UNITED STATES PATENT AND TRADEMARK OFFICE

APPLICATION NO.	FILING DATE	FIRST NAMED INVENTOR	ATTORNEY DOCKET NO.	CONFIRMATION NO.
10/734,922	12/11/2003	Mark C. Morris	H0005667-1170	2263

Office Action Summary

Annotated 2003/0185674 Figure 2

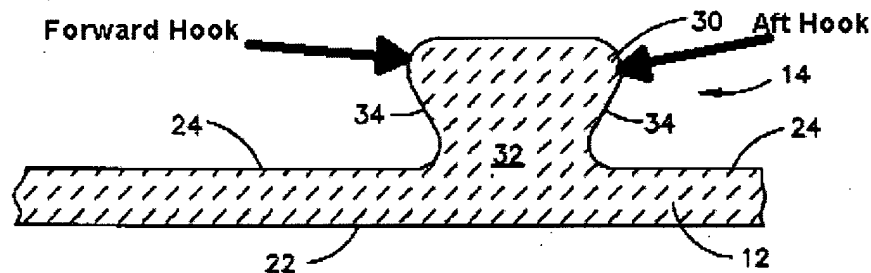
The Alford et al. 2003/0185674 patent application shows ceramic shroud segments 12 having a forward hook and an aft hook (see annotated Fig. 2 below).

The 2003/0185674 patent application does not show spacer seals arranged in spacer channels, nor the aft hanger rail angled surface being on the forward edge of the radially inward side.

Annotated 2003/0185674 Figure 3

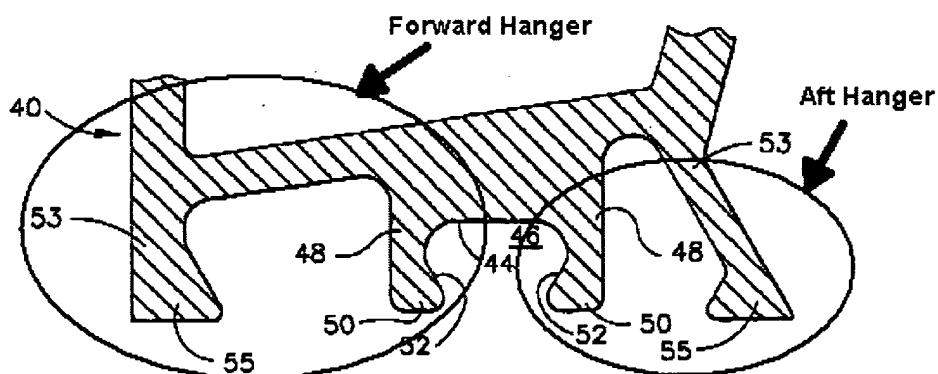
The reference also shows in Fig. 3 a forward hanger and an aft hanger which engages the forward hook and aft hook, respectively.

Additionally, as seen in Fig. 4, rope seals 58 are used between the shroud segments and the hangers such that the rope seals are radially inward from the hangers. Further, when assembled, a plenum assembly comprising cavities 62 and 64 is positioned between and in contact with the at least one forward hanger and the at least one aft hanger. Also, the forward hanger comprises a rail 53 having an o-ring groove 60 positioned circumferentially on a radially inward side. And the aft hanger comprises an aft hanger rail 53 having an angled surface 60.

Annotated 2003/0185674 Figure 2

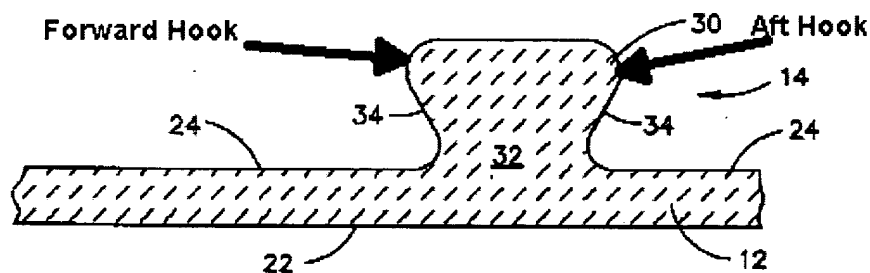
The Alford et al. 2003/0185674 patent application shows ceramic shroud segments 12 having a forward hook and an aft hook (see annotated Fig. 2 below) for the purpose of positioning the ceramic shroud segments to the turbine casing.

Annotated 2003/0185674 Figure 3

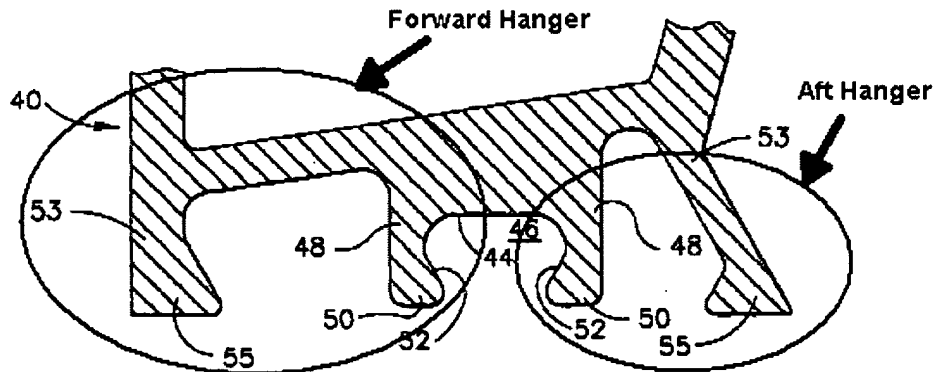
The reference also shows in Fig. 3 a forward hanger and an aft hanger which engages the forward hook and aft hook, respectively.

Additionally, as seen in Fig. 4, rope seals 58 are used between the shroud segments and the hangers such that the rope seals are radially inward from the hangers.
